SUNDRY NOTICES AND REPORTS ON WELLS

Cedar Canyon 23 #1H

OXY USA Inc. respectfully requests to amend the APD for the Cedar Canyon 23 #1H, API No. 30-015-40667 with the following changes.

AMENDED APD:

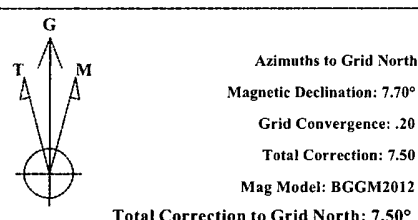
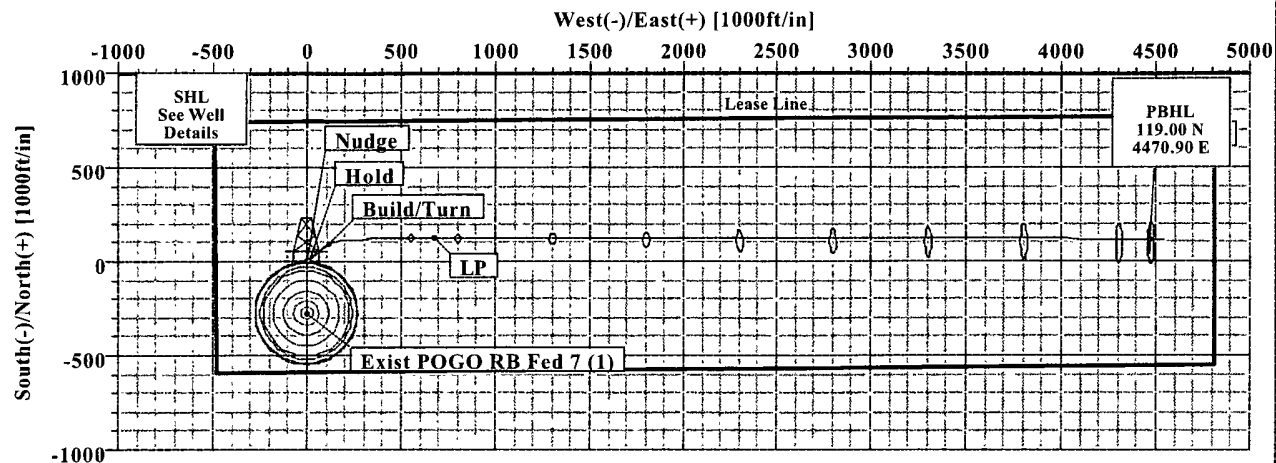
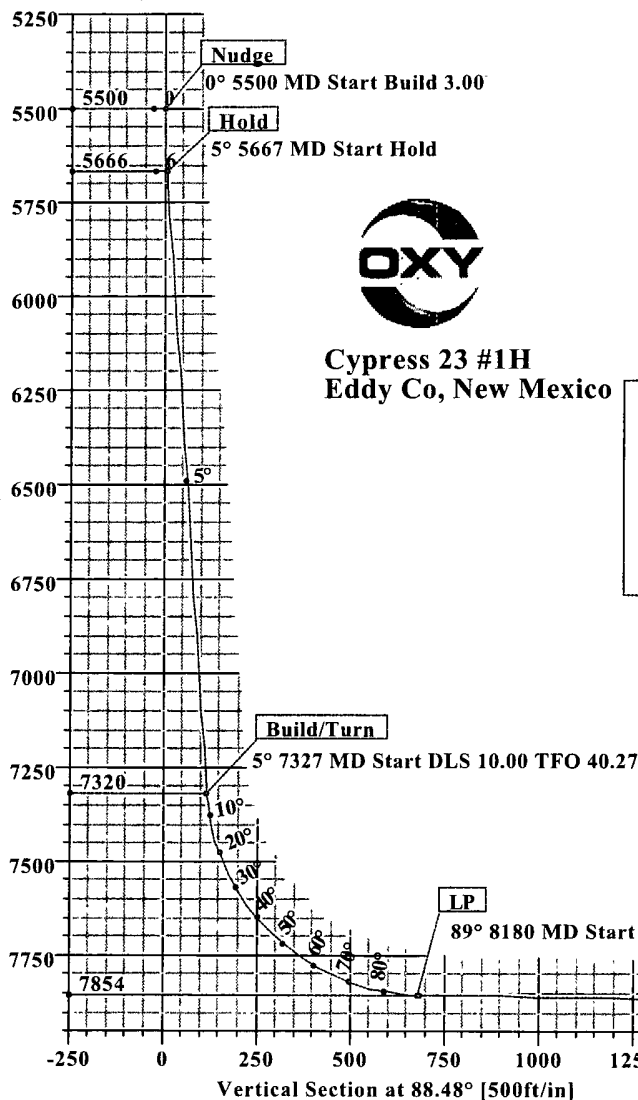
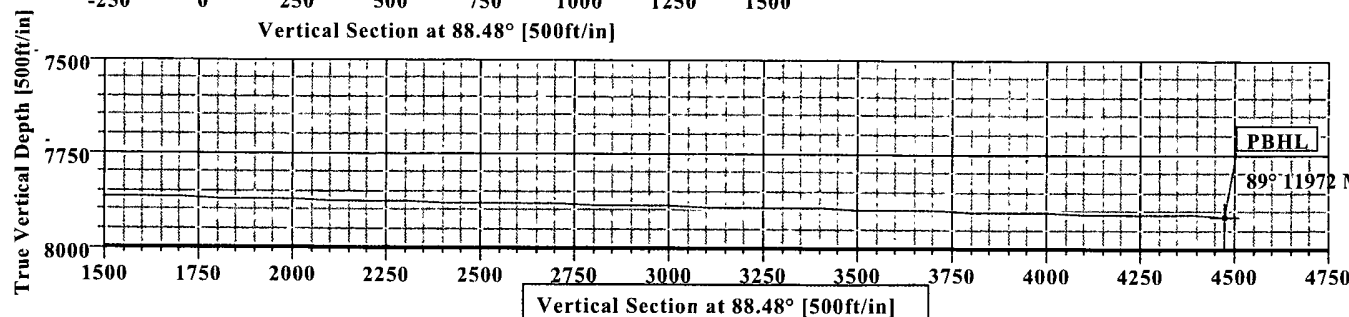
1. Amend the proposed TD's. 7912'-TVD 11972'-TMD
2. Amend proposed directional drilling plan, see attached.
3. Amend intermediate casing program, see attached.
4. Amend production casing cementing program, move DVT, see attached.

- Due to the proximity to an existing well (Riverbend Federal #7. API 30-015-27994) the directional plan has been modified to create an acceptable separation between the wellpaths. New directional plan attached, along with the anticollision analysis.) The TVD at the toe has also been changed to 7912' to follow the formation dip.
- To avoid overdesign, the intermediate casing depth (3150') allows us to run 9 5/8" 36# J55 STC casing. Below are the new design factors.
- To maximize the length of the lateral, the BHL has been changed to reflect this. The new plat and directional plan reflect this change. The new BHL falls within the "producing area", being 1980' FNL and 340' FEL. Cement program has been updated to reflect new volumes. DV tool has been moved to 6500' to minimize the chances of losing circulation on the first stage.
